Assessment of the Jabiluka Project

Report of the Supervising Scientist

World Heritage Committee

After discussion of the Mission's report at its meeting at Kyoto from 30 November 1998 to 5 December 1998, the Committee requested that the Supervising Scientist conduct a full review of scientific issues raised by the Mission. Perceived scientific uncertainty with respect to these issues had led to the Mission's conclusion that the natural values of Kakadu are threatened by the Jabiluka project. This report is in response to that request.

Figure 3.3.1 Comparison of average monthly storage evaporation estimates and point potential and areal potential evapotranspiration rates

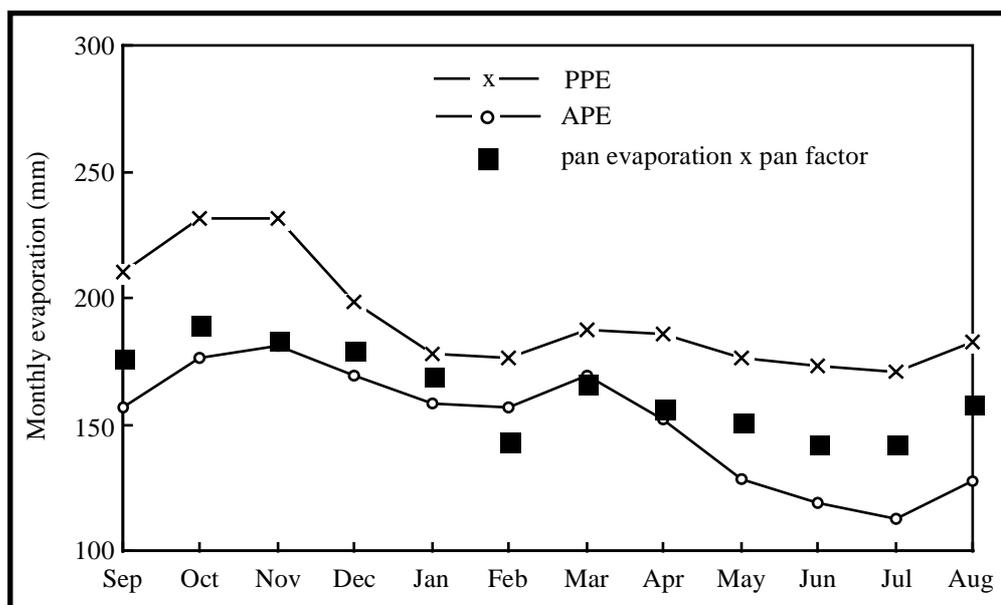
Wasson et al (1998) note the use by ERA of two simple seasonal factors to estimate pond evaporation from pan measurements; 0.6 in the Dry season (May–October) and 0.75 in the Wet season (November–April). They assert that there is a need to check these factors by appropriate modelling that incorporates existing solar radiation data and that the extensive evaporation study conducted at Manton Dam, south of Darwin, needs to be taken into account.

The approach outlined above was adopted by ERA in the draft EIS in 1996 but Wasson et al (1998) seem to have been unaware that ERA adopted a more sophisticated approach in the PER for the Jabiluka Mill Alternative. It was the proposal for the Jabiluka Mill Alternative, presented in 1998, which was the subject of investigations conducted by the Mission of the World Heritage Committee to Kakadu. ERA outlined in Appendix B1 of the PER the procedure adopted in estimating evaporation from the retention pond. Pan factors for each month of the year were adopted following a review of all existing evaporation data relevant to the region by CSIRO (Hatton 1997). The conclusion of Hatton (1997) was that, with the exception of the two months of April and October, the pan factors derived by the Supervising Scientist (Vardavas 1987) should be used in all water balance calculations.

Figure 3.3.1 shows the evaporation rates calculated using the Vardavas (1987) pan coefficients and these are compared to the APE and PPE values. All of the Vardavas calculations are in agreement with the seasonal pattern of the APE and the PPE. For February and March, the estimated storage evaporation rates are lower than the APE and Chiew and Wang (1999) concluded that this could be due to errors in the recorded pan evaporation (because of the difficulty in accurately estimating pan evaporation when rainfall is high) or errors in the APE estimates. The overall conclusion was, however, that the best estimates of pond evaporation for Jabiluka would be obtained by using the results of Vardavas (1987).

Figure 3.3.2 Relationship between evaporation and rainfall at Jabiru for the months of January, February and March

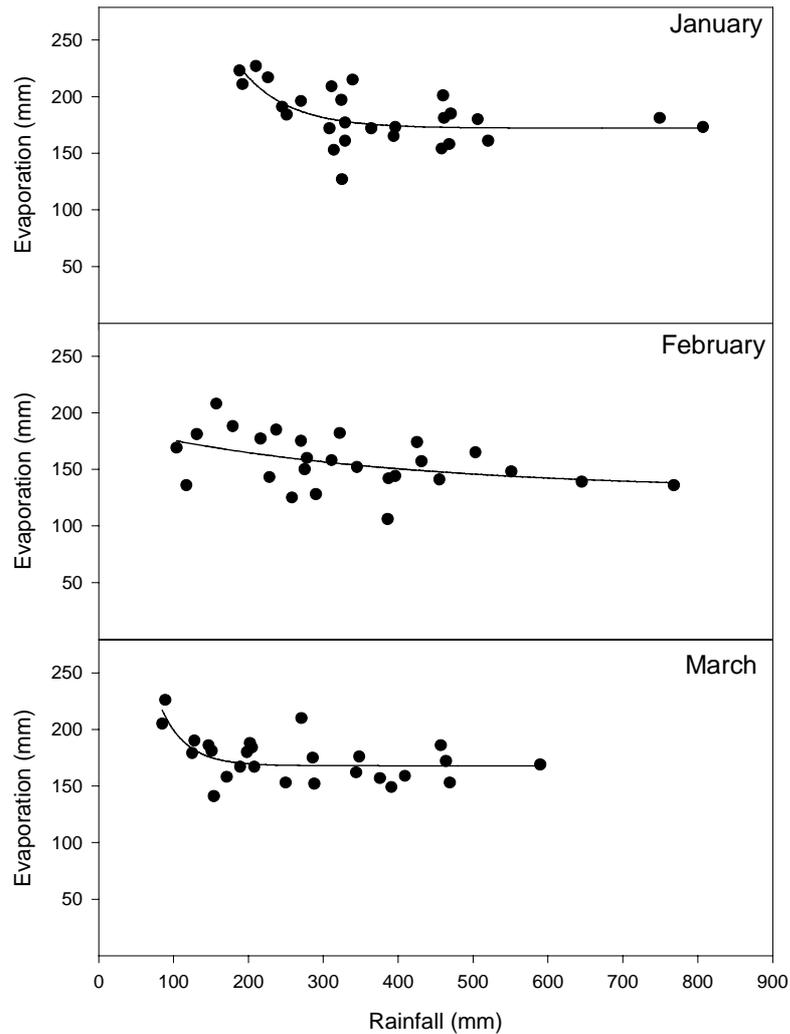
Wasson et al (1998) state that the principal source of error in the evaporation calculations of ERA arises from neglect of the inverse relationship between evaporation and rainfall which arises because solar radiation is lower on cloudy days than on sunny days. They suggest that the adoption of long-term mean values for the pan factors will result in a significant over-estimate of evaporation in very wet months and that this effect could exceed 10% during very wet years.

Chiew and Wang (1999) investigated the significance of the inverse relationship between evaporation and rainfall using data from a number of meteorological stations in the north of the Northern Territory including Jabiru, Maningrida, Middle Point and Darwin. They found that a linear inverse relationship was statistically significant for both the annual data and the quarterly data at each station and that it was most significant at Jabiru. They concluded that this effect should be taken into account in their modelling of the water management system at Jabiluka and they evaluated the significance of the effect on the required pond volume. The conclusion reached was that the retention pond volume would need to be increased by about 3% as a result of both the inverse relationship and interannual variability in evaporation.

There is, however, evidence that even this small effect is an over-estimate because, during the principal months of the Wet season (December to March), cloud cover is often extensive even when there is no rainfall. As a result, the relationship between evaporation and rainfall during any given month will not be linear but evaporation will tend towards a constant lower value at higher rainfall values. This effect is clearly illustrated in figure 3.3.2 where evaporation at Jabiru is plotted against rainfall for the principal Wet season months of January, February and March. The line through the data in each case is of the form

Figure 3.4.1 Variation of saturated vapour pressure (upper graph) and absolute humidity (lower graph) with temperature at atmospheric pressure $P=100\text{kPa}$

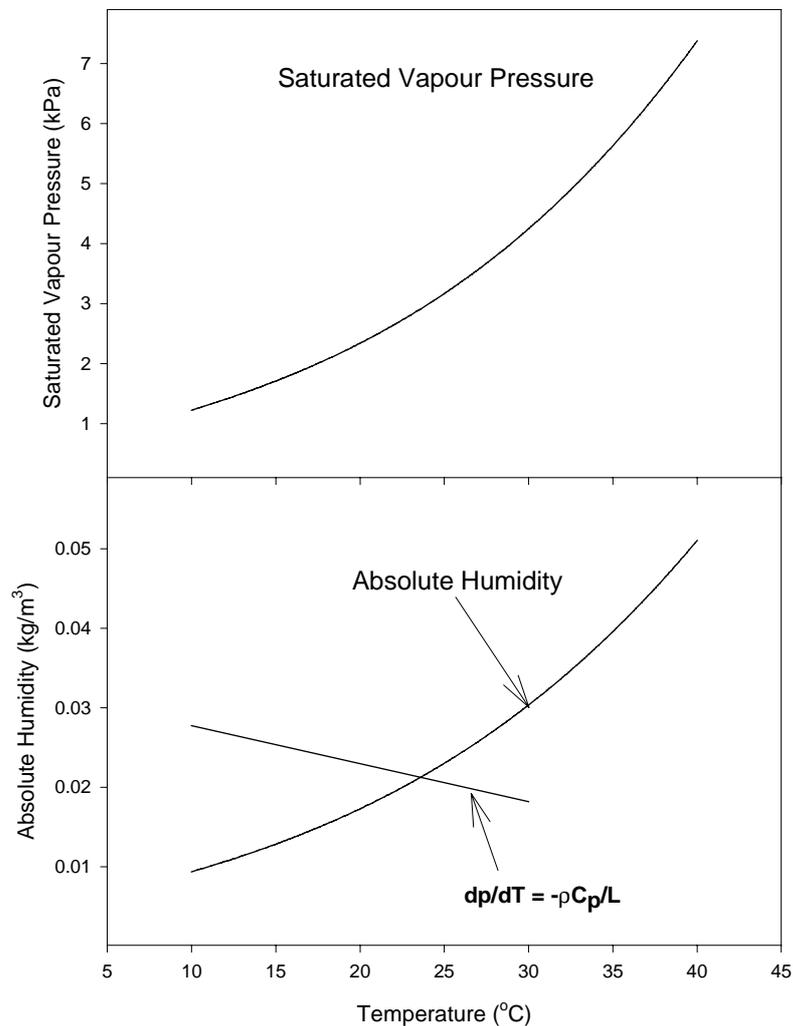
where Δp is the change in humidity, L is the latent heat of vaporisation, ρ is the density of air and C_p is the specific heat of air. Using $L = 2.43 \cdot 10^6 \text{ J/kg}$ (Kaye & Laby 1978, p 235), $\rho = 1.149 \text{ kg/m}^3$ (Kaye & Laby 1978, p 18) and $C_p = 1010 \text{ J/kg}^\circ\text{C}$ (CRC 1995, p 6-1), the decrease in temperature resulting from the vaporisation of the water would be 16°C . As can be seen from figure 3.4.1, the absolute humidity (ie fully saturated) at 14°C is about 0.012 kg/m^3 , a figure considerably less than the initial vapour density. Hence, the target evaporation figure cannot be achieved.

For 60% relative humidity, $p_0 = 0.0182(\text{kg/m}^3)$ at $T_0 = 30^\circ\text{C}$. This line is shown in figure 3.4.1. It intercepts the graph of absolute humidity at about 23.6°C which, as proposed by Wasson et al (1998), is the wet bulb temperature (estimated as 23.8°C from the data in CRC (1995) p15–22). At this temperature the absolute humidity is $0.0213 (\text{kg/m}^3)$. Thus the maximum quantity of water that can be evaporated is

$$p = 0.0213 - 0.0182 = 0.0031(\text{kg} / \text{m}^3).$$

This value is about 40% of the design value presented in Appendix J of the draft EIS.

These observations, however, do not imply that a major error exists in the proposal put forward for water management at the Jabiluka mine. If the latent heat of evaporation were to be supplied (for example, by standard humidifiers) there would be no need to take the above drop in temperature into account and the volume of water that could be evaporated would remain that estimated in the EIS and the PER. The Supervising Scientist consulted the engineer who advised ERA on this issue (Mr Douglas Rudd, Kinhill Pty Ltd) who advised that the calculations were provided to indicate the capacity of the ventilation system to dispose of additional water through evaporation. It was recognised that energy input via heaters, hot air blowers or staged misting/humidifiers would be required to achieve the full indicated disposal volume. These issues were, however, matters to be dealt with at the detailed design stage of the project when the potential of this method of water disposal could be evaluated (ie a cost benefit analysis) in a comparison with other methods such as increasing the area of the retention pond.

The area of the retention pond would need to rise from 9 ha to approximately 13 ha to provide the required evaporative capacity if no evaporation occurs in the ventilation shafts. This area is small compared to the total area of retention and tailings ponds proposed in the original JMA proposal and is only 2% of the disturbed area at the nearby Ranger mine. The environmental impact arising from such an increase, should it need to be part of the project, is, therefore, not considered to be significant.
